ExG/COMP
Informal document 8 (2004)
13 October 2004

ACTIVITIES OF THE INFORMAL AD HOC EXPERT GROUP

Reference Model of the TIR Procedure

Issue 57 (1.3 TIR Carnet life cycle use case)

Figure 1.4 TIR Carnet life cycle activity diagram

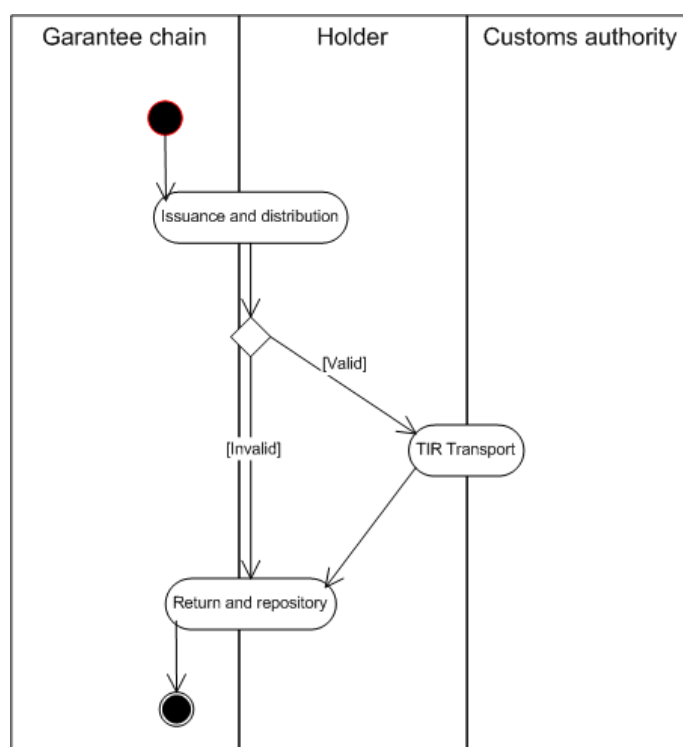
1. While working on the elaboration of document ExG/COMP/2004/21, the secretariat noted that not in all situations the issuance and distribution of TIR Carnets is succeeded by the beginning of a TIR Transport. If the TIR Carnet validity has expired, the TIR Carnet holder must return it to his national association, which sends it back to the international organization. In order to reflect this, Chapters 1.3.3 and 1.3.4 of the Reference Model need to be amended (Issue 57).

3. In Chapter 1.3.4, replace Figure 1.4 by the following figure:
